ITB-15-01
ADDENDUM #3 *FHM*
KIPLING MULTI-USE TRAIL

Date: February 13, 2015
Bid Number: ITB-15-01 **City Project Number:** S-03-11 **CDOT Project Number:** STU 391A-008(18583)
Bid Due Date: **TUESDAY, FEBRUARY 24, 2015 BY 1:00 PM OUR CLOCK**

JOB NAME:
 Wheatridge Town Ctr N. Proposed LED Fixture/Pole

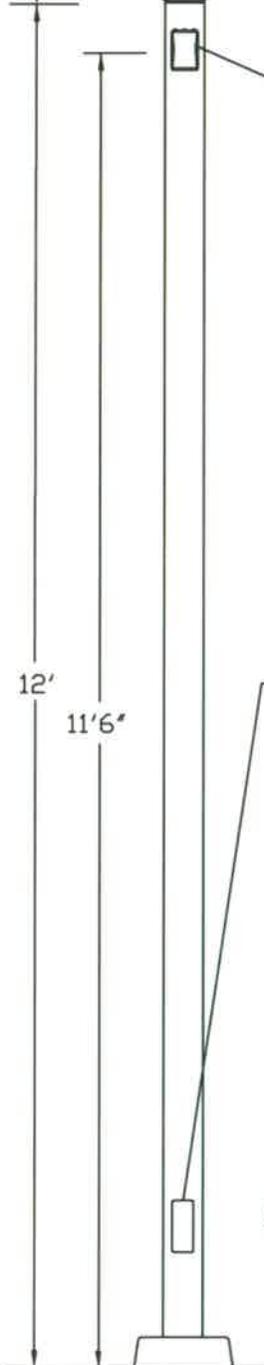
Question: Does the City have a standard lighting fixture?

Answer: Yes, see attached. Street and Pedestrian lights will need to meet the City standard or approved equal. The City standard was installed recently installed at 32nd & Youngfield and at 44th and Vance.
